AMF HARLEY-DAVIDSON SERVICE BULLETIN

No. M-751

June 29, 1979

REAR BRAKE PEDAL STOP BOLT JAMNUT / 1979 XLH, XLS

REAR BRAKE PEDAL ADJUSTMENT (Behind Sprocket Cover Below Engine)

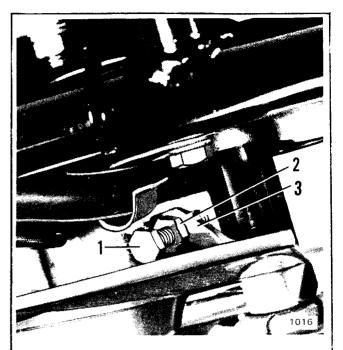
The brake pedal stop bolt is located underneath the right side of the engine just below the rear brake pedal as shown in the illustration.

Check jamnut (2) for tightness and check brake linkage for proper adjustment as follows:

Work rear brake pedal by hand to determine free play (movement before plunger contacts piston in master cylinder). Free play, of plunger should be approximately 1/16 inch to be sure rear brake cylinder hydraulic pressure is relieved when brake pedal is released.

To adjust free play, loosen jamnut (2) and turn stop bolt (1) inward (clockwise) to decrease free play, or outward (counterclockwise) to increase free play. When 1/16 free play is obtained, tighten jamnut (2) against shaft lever (3) while holding stop bolt (1) in position. Recheck free play.
